#### STAFF REPORT

**AGENDA ITEM:** 3880 Laverne Avenue North Zoning Map Amendment and Minor Subdivision

#### **RESOLUTION NO. 2017-013**

# CERTIFICATE OF SURVEY MINOR SUBDIVISION

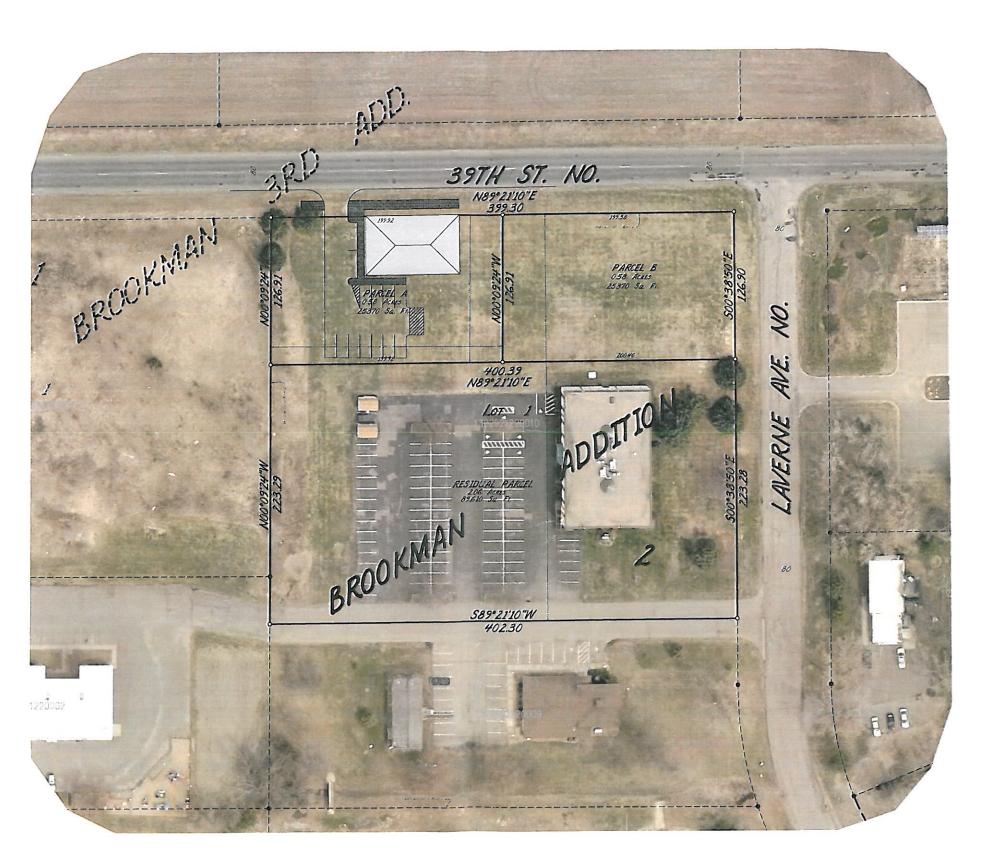
- Access Management. 39<sup>th</sup> Street access management points must be carefully coordinated in order to ensure it functions properly.
  - o Recommended Combined Access Required. As a result, it is a condition of approval that driveway access be combined for Parcel A and B.

- *Need for Easements*. The typical design section for 39<sup>th</sup> Street, which was designed with the intention to match the Village Parkway, suggests the need for a 10-foot easement along North and South sides of this street.

- o This does not allow for the zero lot line design the VMX zoning district encourages.
  - o Therefore, it is a recommended condition of approval that an easement be required to prevent a building being placed at a zero-lot line setback, as the VMX district allows.

- *Sewer and Water*. The 39<sup>th</sup> Street reconstruction extended a new sewer and water main stub that will serve both parcels. The plans will need to reflect stub locations to avoid conflict for stubs to serve both parcels.

- *Stormwater*. The site plan will need to create and obtain necessary approvals for a stormwater management plan.
  - Stormwater drainage will need to be maintained, and storm sewer connections to 39<sup>th</sup>
     Street system must be at existing or reduced runoff rates.

**Commented [EB3]:** The City Engineer recommended that combined driveway access to Parcel A and B from 39<sup>th</sup> Street be provided. The Planning Commission felt access would be better served by Laverne Avenue and so recommended limiting only one access to 39<sup>th</sup> Street, combined or limited to either Parcel A or Parcel B.

- 6) Building setback locations are subject to City approval and must allow for planned street improvements.
- 7) Only one driveway access to 39<sup>th</sup> Street is permitted. Access may be combined or limited to only Parcel A or Parcel B.

- 8) 8-inch watermain stub and 8-inch sanitary sewer main stub shall be shown on the plans and approved by the City Engineer prior to commencement of construction activity to ensure that the building placement does not conflict with the ability of the stubs to service both parcels.

- 9) The site plan is subject to a storm water management plan meeting State, Valley Branch Watershed District and City rules and regulations. All applicable permits must be obtained if needed.

- 10) Stormwater drainage patterns must be maintained as part of any site development.
- 11) Storm sewer connections to the 39<sup>th</sup> Street system must be at existing or reduced runoff rates and volumes.
